**GE Hitachi Nuclear Energy**

June 24, 2020

M200087

**Subject: 10 CFR Part 21.21(d)-Reportable Condition:  
Non-Conservative BWR/6 Side Entry Orifice (SEO) Loss Coefficients**

**Figure 1 Illustrations of BWR/6 interior (central core) cells with surrounding support beams  
(not to scale)**

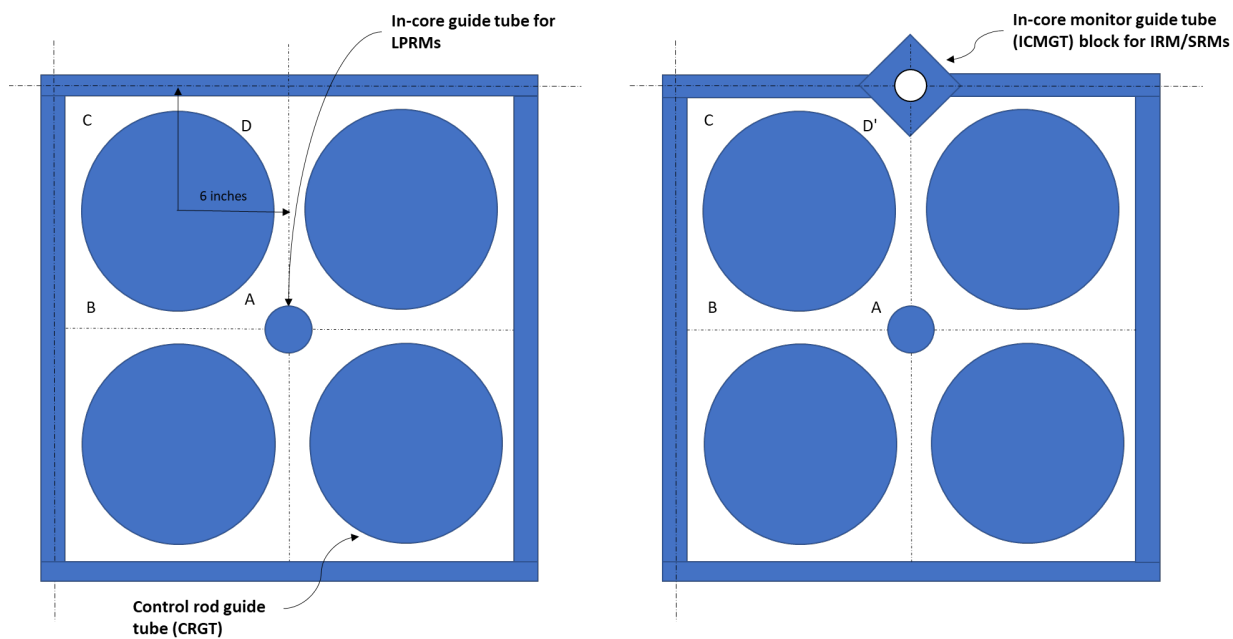
monitoring databanks to address the issue. However, in 2002, the effect of in-core instrumentation tube locations on the pressure loss coefficient was not known. This issue was recently discovered following detailed reviews of core support plate drawings. GNF determined that the IRM/SRM locations have more restrictive inlet flow areas immediately upstream of the SEO, which justifies an increased SEO loss based on full-scale experimental data. For US BWR/6 plants, the increase in the updated SEO loss for these locations is approximately 98% of the most restrictive (two beam) value. Local Power Range Monitors (LPRMs) are another form of in-core instrument, but these locations are not affected by the issue. The presence of LPRMs has a relatively small effect on SEO inlet flow area and was considered in the choice of the original SEO loss coefficients. Figure 1 shows a diagram of the geometry of interest (not to scale). The SEO inlet locations are designated A, B, C, D or D' and the dashed lines are lines of symmetry. In the 2002 notification, location D' was not identified.

For affected plants that use GNF core monitoring software, the long-term corrective action is to implement an updated core monitoring databank with corrected SEO loss coefficient values. Affected plants should contact their GNF account representative for schedule and delivery dates. If necessary, a short-term corrective action such as an administrative MCPR penalty on IRM/SRM locations, should be applied to the core monitoring system. An effective short-term measure would be to assure that IRM/SRM locations are 0.02 less than the Maximum Fraction of Limiting CPR limit (e.g.,  $MFLCPR_{limit} = 1.00$ ). This condition is met if the core wide MFLCPR is 0.02 below the limit (e.g.,  $MFLCPR < 0.98$ ), because the IRM/SRM locations will be bounded. Note that this recommended short term or interim measure was developed on a standalone basis and does not supplant any existing MFLCPR limit reductions established for other purposes.
